**Subject: Palmdale Hybrid Power Project – Docket 08-AFC-9
City of Palmdale’s Supplemental Information and Comments on the
Preliminary Staff Assessment for the Palmdale Hybrid Power Project**

**CITY OF PALMDALE'S SUPPLEMENTAL INFORMATION AND COMMENTS
ON THE PRELIMINARY STAFF ASSESSMENT FOR THE
PALMDALE HYBRID POWER PROJECT**

Projection: NAD 83, Zone 11
 Path: S:\active projects\Palmdale
 Power Plant Bio 6554000247\graphics\mxd\2010
 Date: 04/16/10

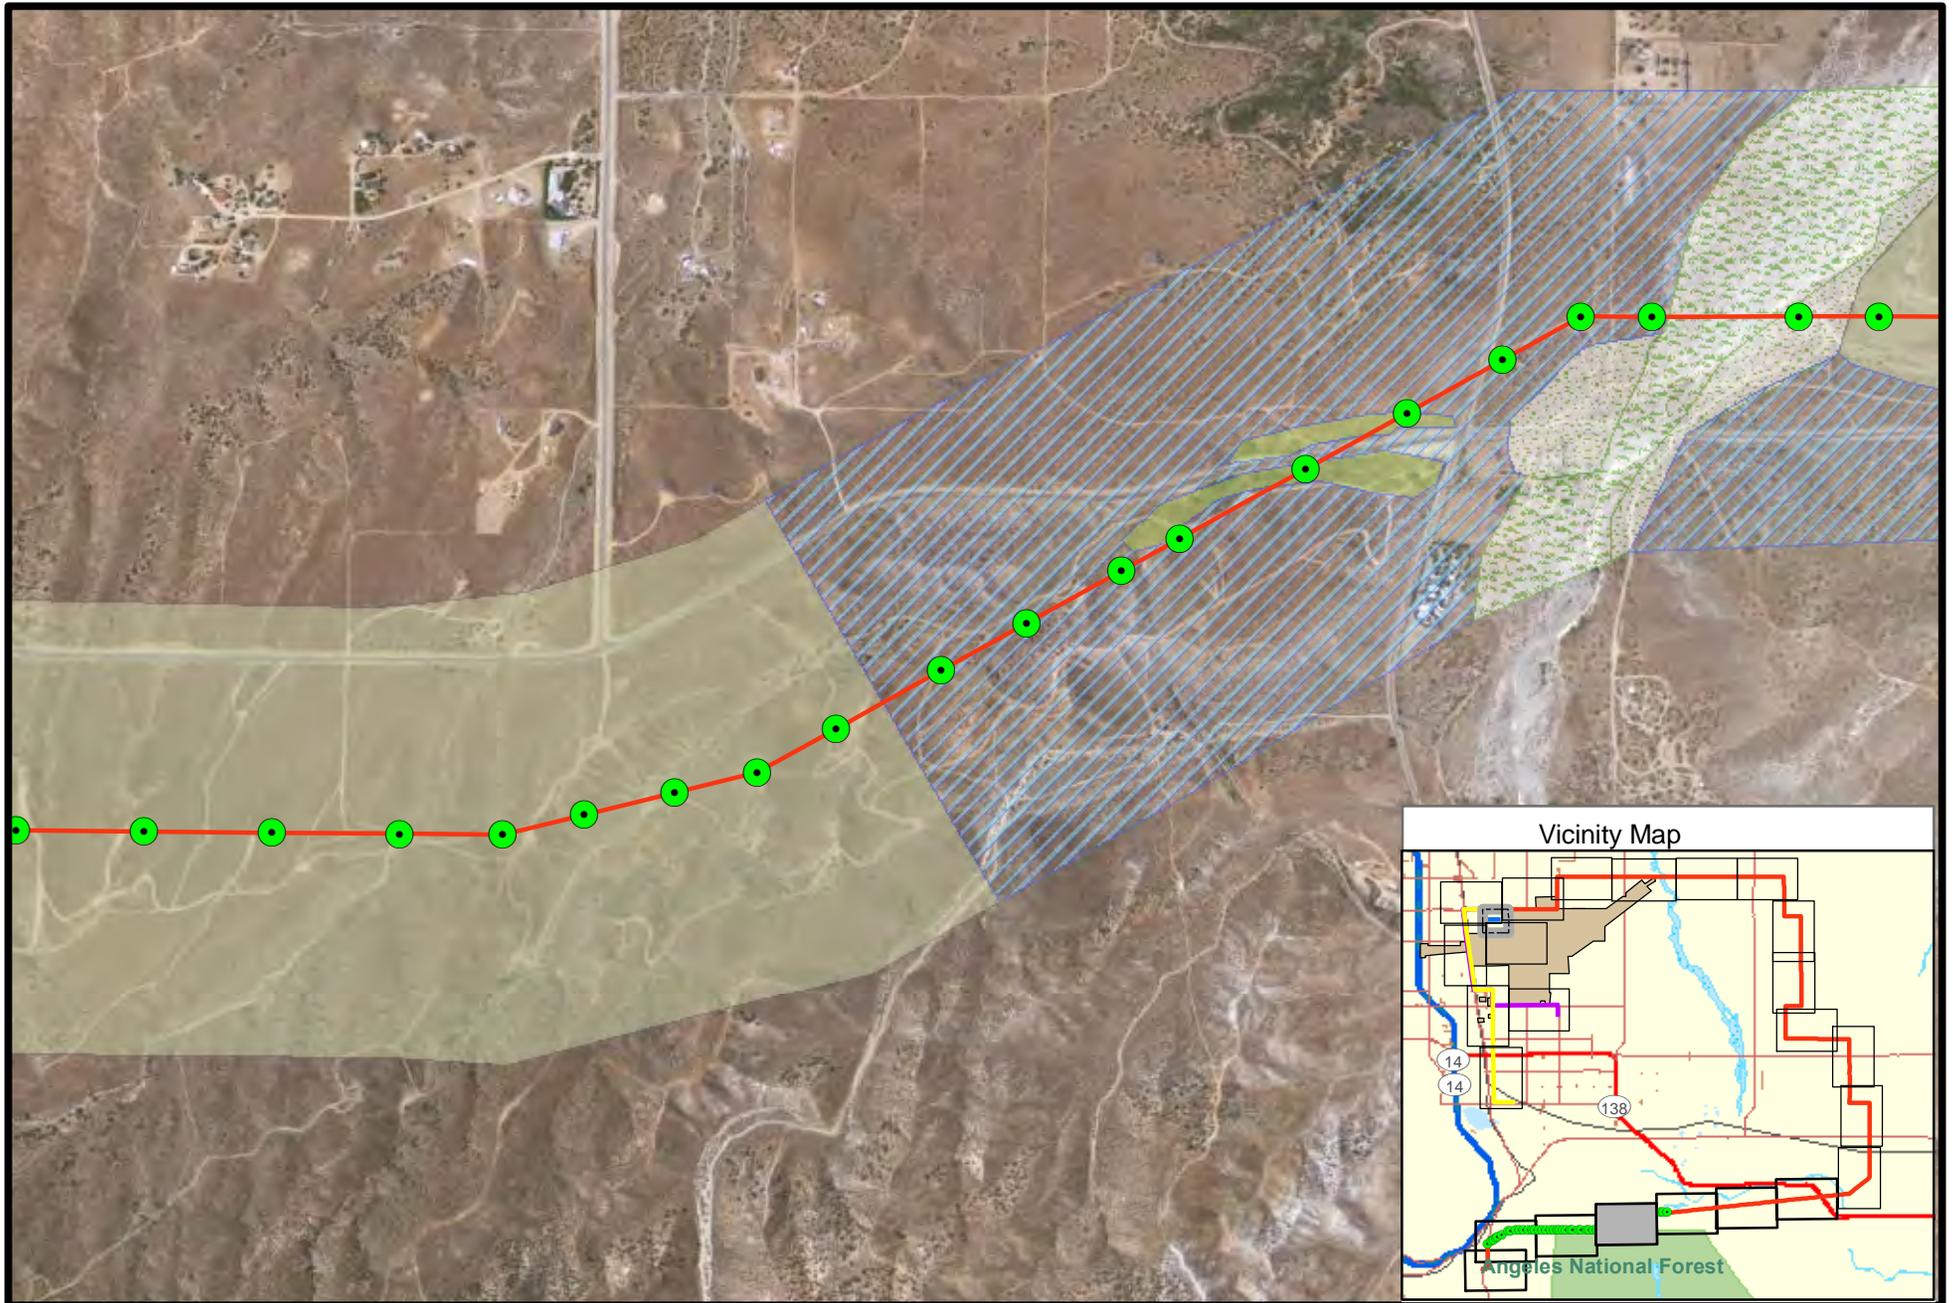
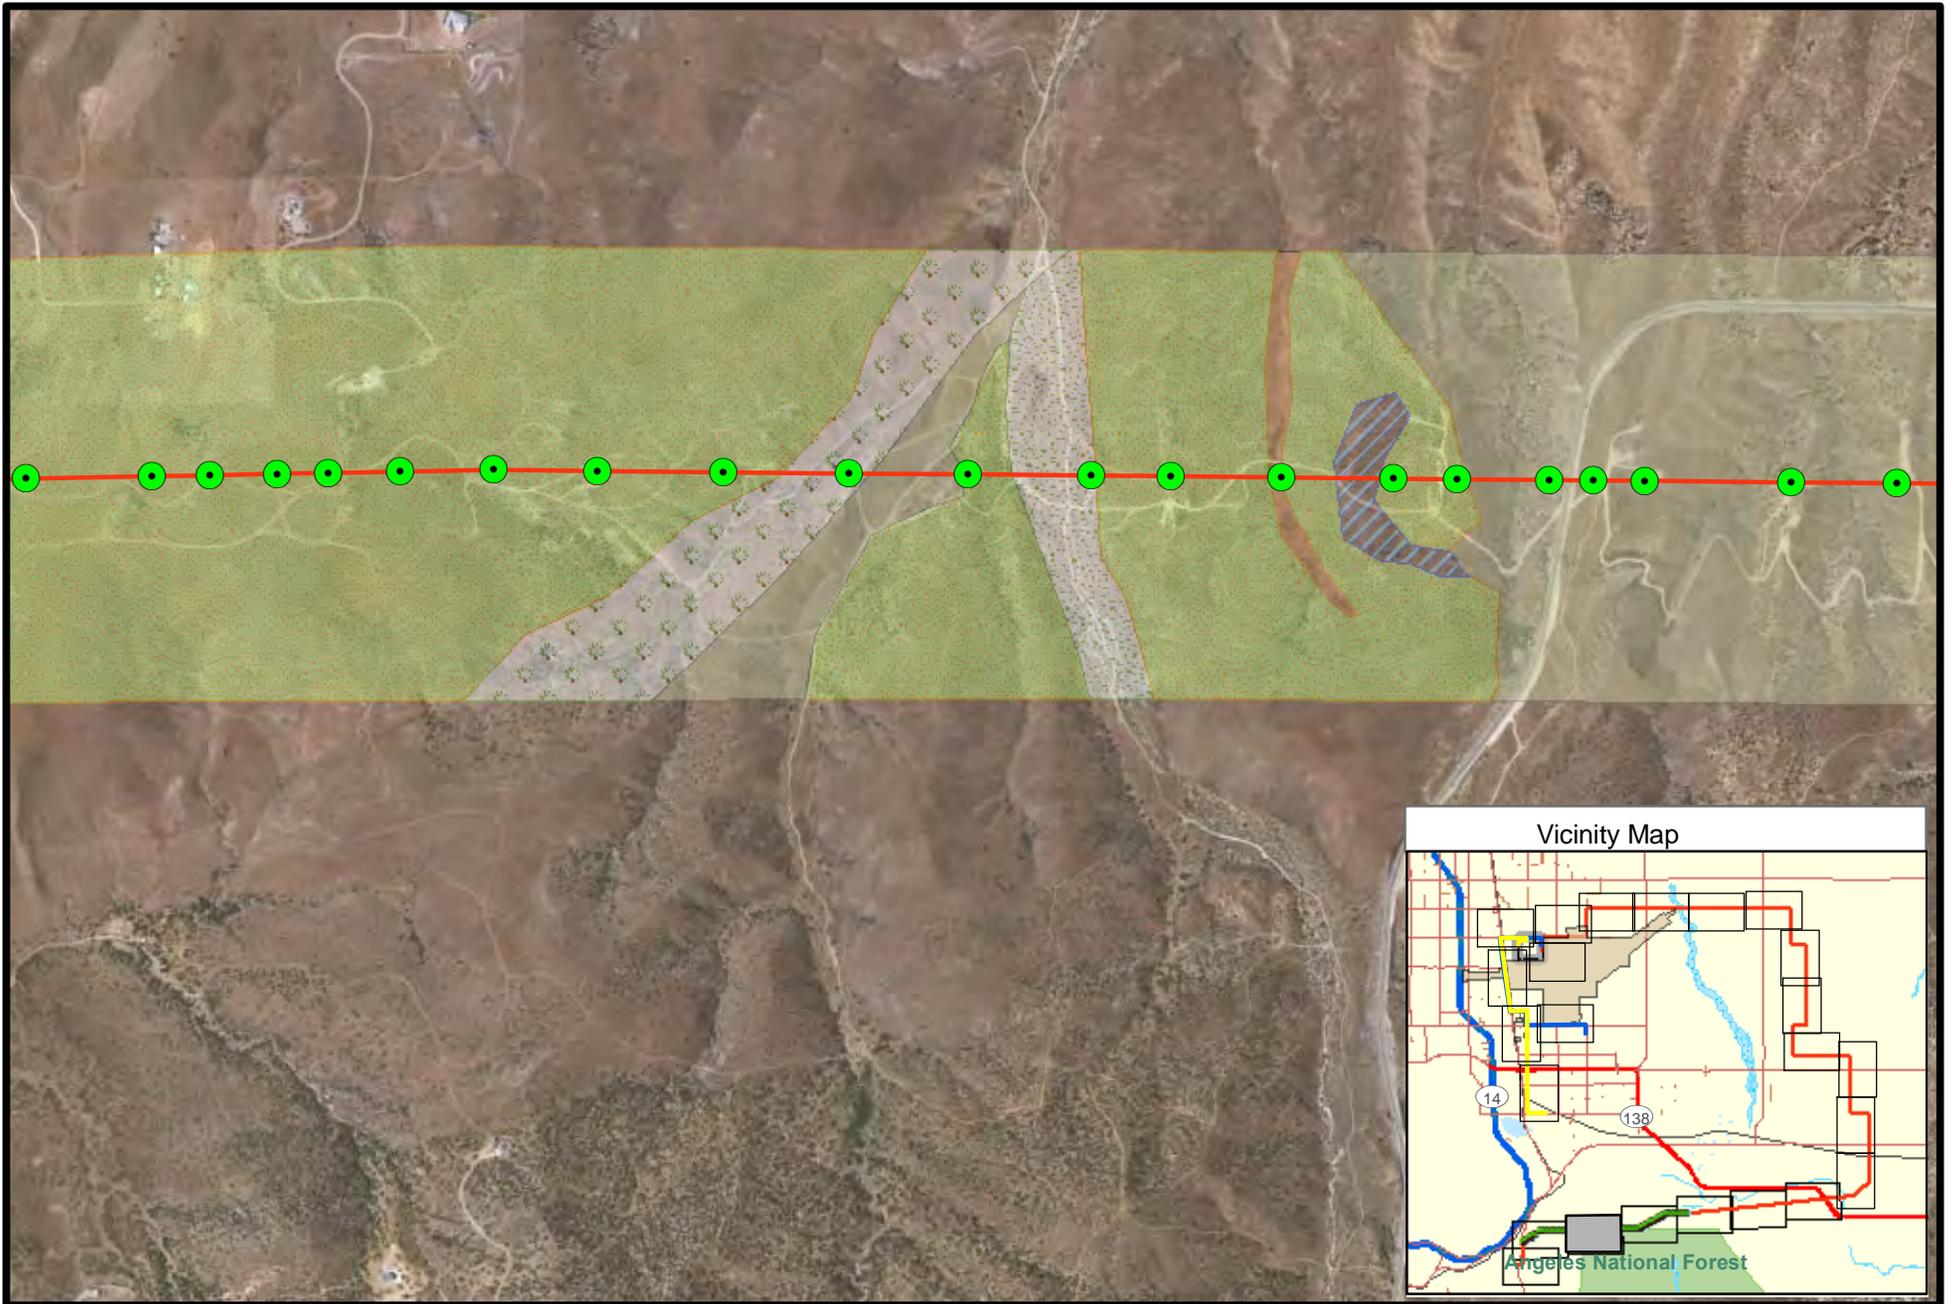
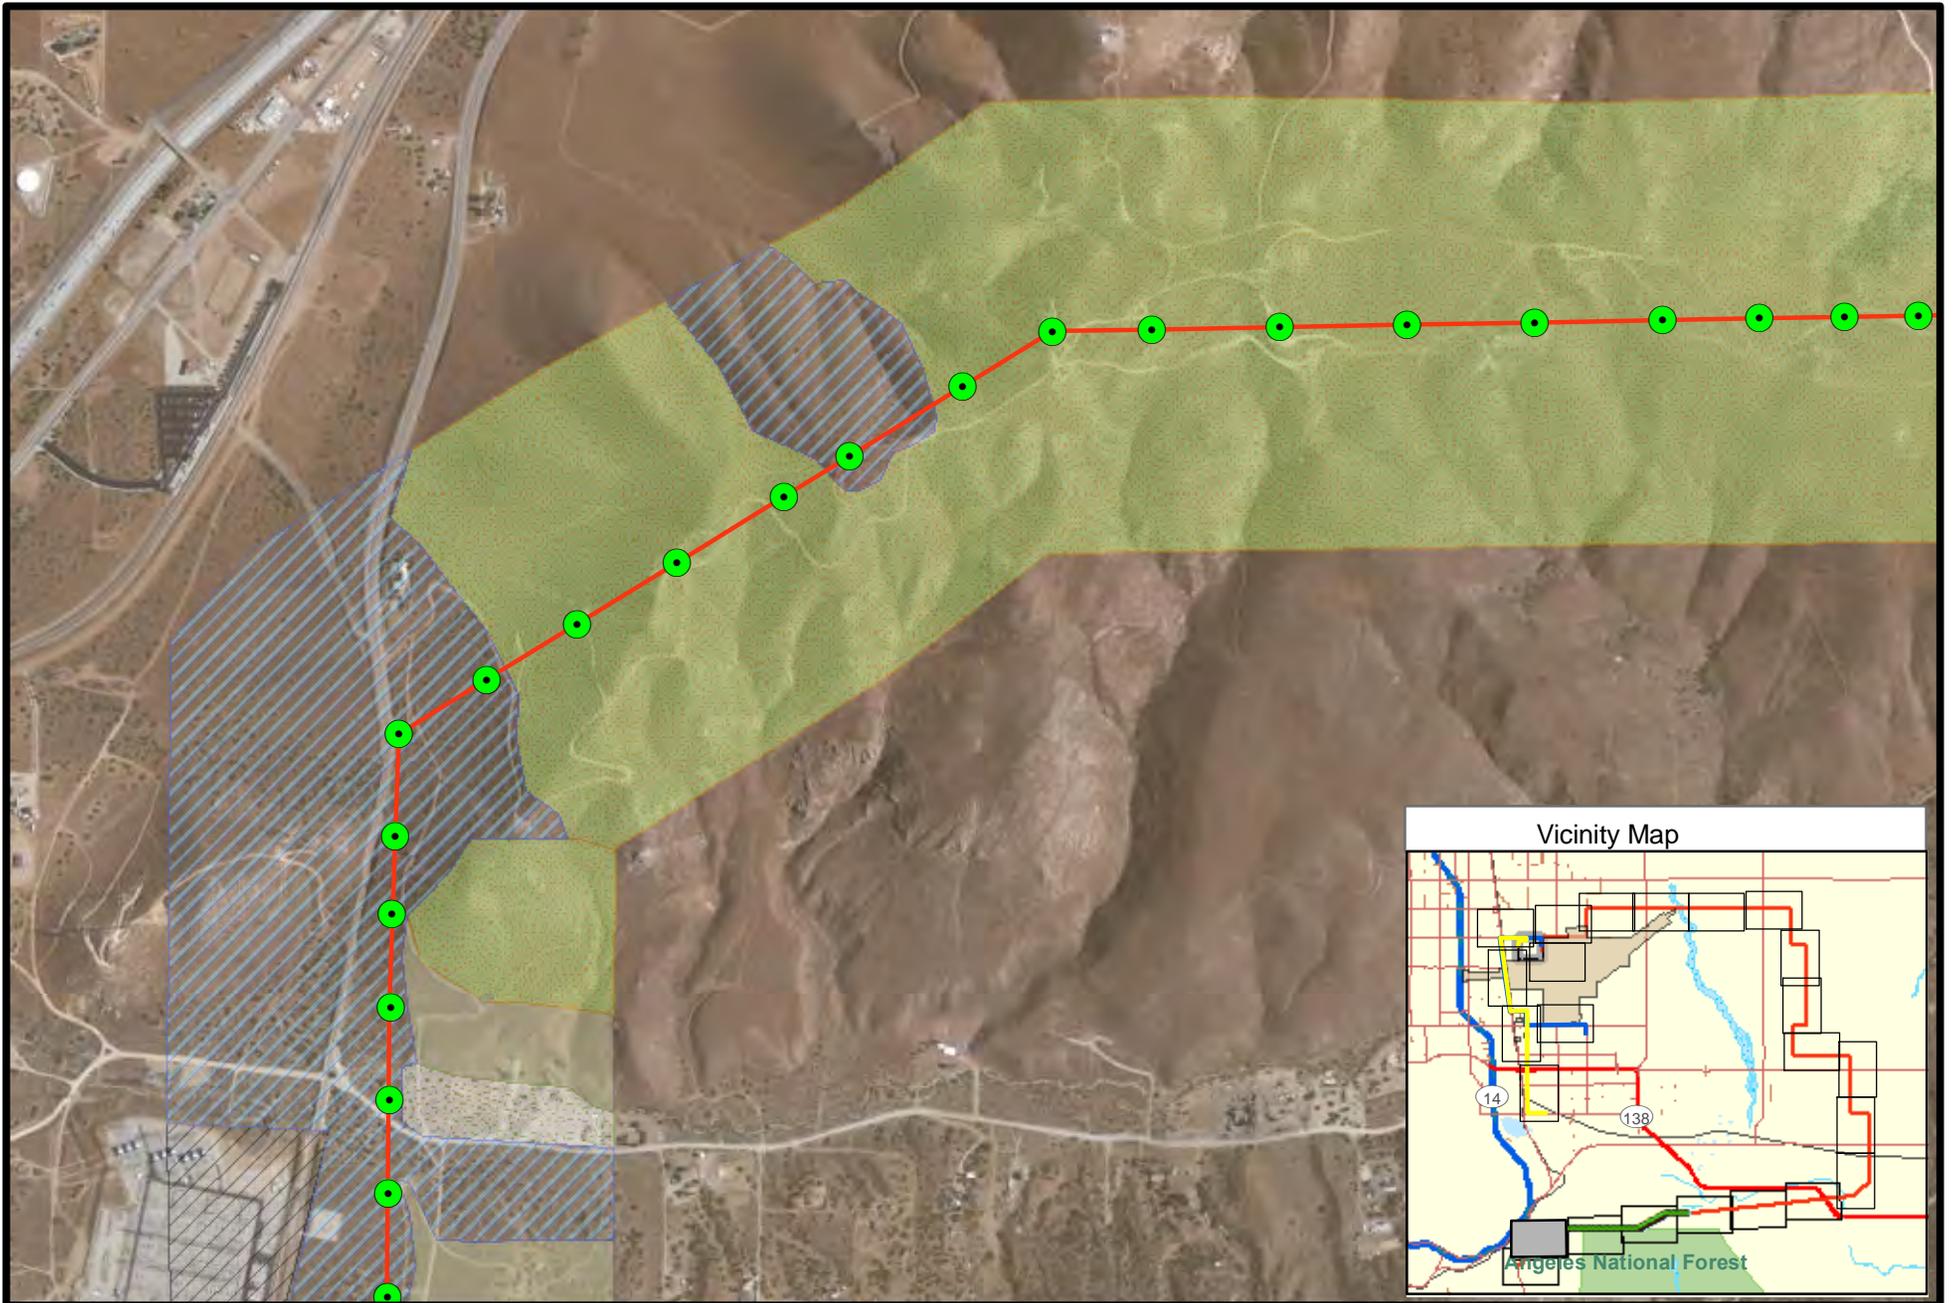
2. Revised Vegetation Mapping

One of the Applicant's consultants (AMEC Earth and Environmental) reviewed the vegetation mapping that had been provided in the AFC (Appendix H, Figure 6). Based on this review, it was concluded that no changes were needed to the vegetation mapping of the power plant site, reclaimed water pipeline or Segment 1 of the transmission line. However, some refinement of the mapping along Segment 2 of the transmission line was needed. The revised vegetation maps along this portion of the Project are provided in Attachment BR-3. The revisions to the mapping result in changes to the number of acres of the vegetative communities by the PHPP as shown in the Revised AFC Table 5.3-6R below. The changes are a combination of the new vegetation mapping as well as further refinements in project design.
